<b>Product / Process Change Notification (PCN)</b>	
<input type="checkbox"/> Major Change <input checked="" type="checkbox"/> Minor Change	
<b>PCN Number:</b> PCN_WCAP-CSGP_20241018  <b>Affected Series:</b> WCAP-CSGP  <b>Affected Order Codes:</b> 885012005064, 885012005065, 885012005086R, 885012005087R, 885012005088R, 885012005089R, 885012005090R, 885012104011, 885012105007, 885012105008, 885012105021, 885012106006, 885012106006R, 885012107005, 885012108018, 885012109002, 885012109006, 885012109010, 885012109014, 885012109015, 885012205087, 885012205088, 885012206121  <b>PCN Date:</b> 2024-07-18 (YYYY-MM-DD) <b>Effective Date:</b> 2024-10-18 (YYYY-MM-DD)	<b>Change Category:</b> <input type="checkbox"/> Equipment/Location <input checked="" type="checkbox"/> General Data <input type="checkbox"/> Material <input type="checkbox"/> Process <input type="checkbox"/> Product Design <input type="checkbox"/> Shipping/Packaging <input type="checkbox"/> Supplier <input type="checkbox"/> Software

**Details of Change:**

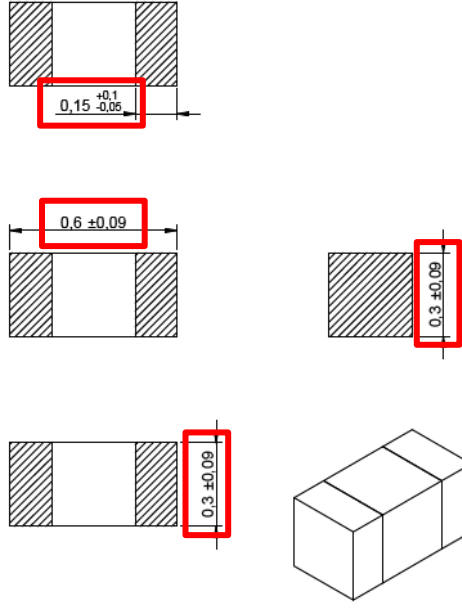
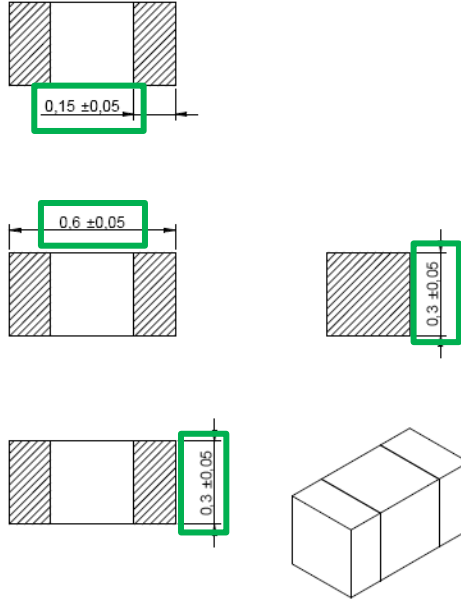
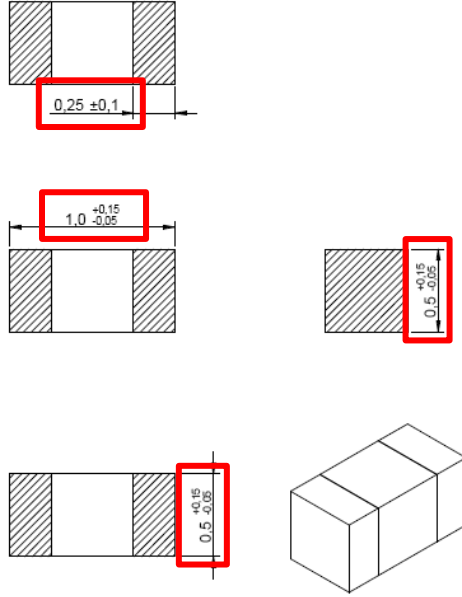
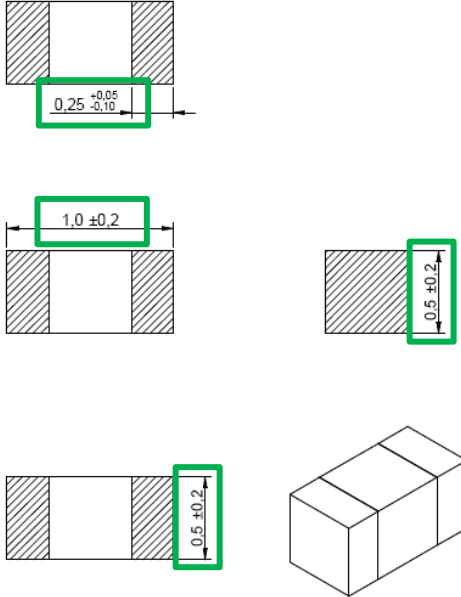
2. Correction of the dimension specification. Corrected dimensions are marked with a red box **before** change and green box **after** change.

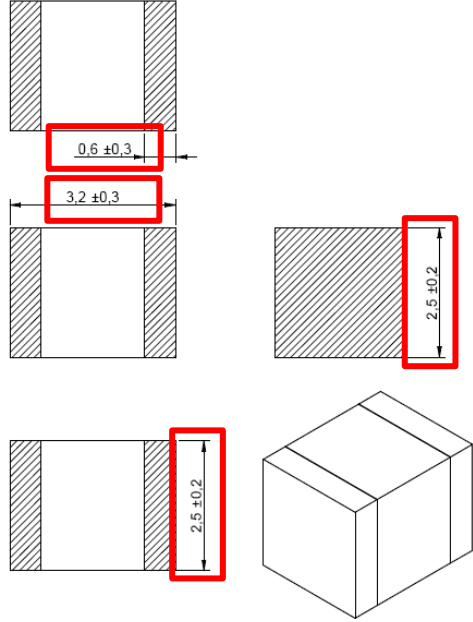
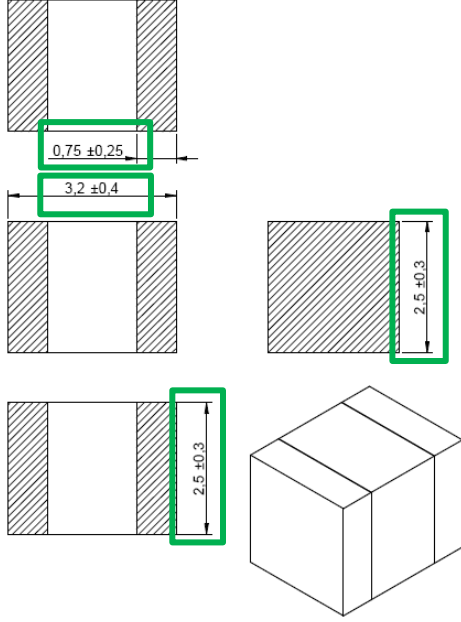
- Correction of the packaging specification. Corrected dimensions and tolerances are marked with a red box **before change** and green box **after change**.

<b>Affected Order Codes</b>	885012005064, 885012005065, 885012005086R, 885012005087R, 885012005088R, 885012005089R, 885012005090R, 885012105021, 885012205087, 885012205088																											
<b>Before Change</b>	<p><b>Packaging Specification - Tape and Reel: [mm]</b></p>  <table border="1"> <thead> <tr> <th></th> <th>A0</th> <th>B0</th> <th>W</th> <th>T</th> <th>T1</th> <th>P0</th> <th>P1</th> <th>P2</th> </tr> </thead> <tbody> <tr> <td><b>tolerance</b></td> <td>typ.</td> <td>typ.</td> <td>+0,3/ -0,1</td> <td>ref.</td> <td>max.</td> <td>±0,1</td> <td>±0,1</td> <td>+0,05</td> </tr> <tr> <td><b>value</b></td> <td>0,70</td> <td>1,20</td> <td>8,00</td> <td>0,80</td> <td>0,10</td> <td>4,00</td> <td>4,00</td> <td>2,00</td> </tr> </tbody> </table>		A0	B0	W	T	T1	P0	P1	P2	<b>tolerance</b>	typ.	typ.	+0,3/ -0,1	ref.	max.	±0,1	±0,1	+0,05	<b>value</b>	0,70	1,20	8,00	0,80	0,10	4,00	4,00	2,00

A0	B0	W	T	T1	P0	P1	P2																				
<b>tolerance</b>	typ.	typ.	+0,3/ -0,1	ref.	max.	±0,1	±0,1	+0,05																				
<b>value</b>	0,70	1,20	8,00	0,80	0,10	4,00	4,00	2,00																				
<b>After Change</b>	<p><b>Packaging Specification - Tape: [mm]</b></p>  <table border="1"> <thead> <tr> <th>Tape Type</th> <th>A0 (mm)</th> <th>B0 (mm)</th> <th>W (mm)</th> <th>T (mm)</th> <th>T1 (mm)</th> <th>P0 (mm)</th> <th>P1 (mm)</th> <th>P2 (mm)</th> </tr> </thead> <tbody> <tr> <td></td> <td>typ.</td> <td>typ.</td> <td>+0,3/ -0,1</td> <td>ref.</td> <td>ref.</td> <td>±0,1</td> <td>±0,05</td> <td>±0,05</td> </tr> <tr> <td>1a</td> <td>0,40</td> <td>0,70</td> <td>8,00</td> <td>0,55</td> <td>0,10</td> <td>4,00</td> <td>2,00</td> <td>2,00</td> </tr> </tbody> </table>	Tape Type	A0 (mm)	B0 (mm)	W (mm)	T (mm)	T1 (mm)	P0 (mm)	P1 (mm)	P2 (mm)		typ.	typ.	+0,3/ -0,1	ref.	ref.	±0,1	±0,05	±0,05	1a	0,40	0,70	8,00	0,55	0,10	4,00	2,00	2,00
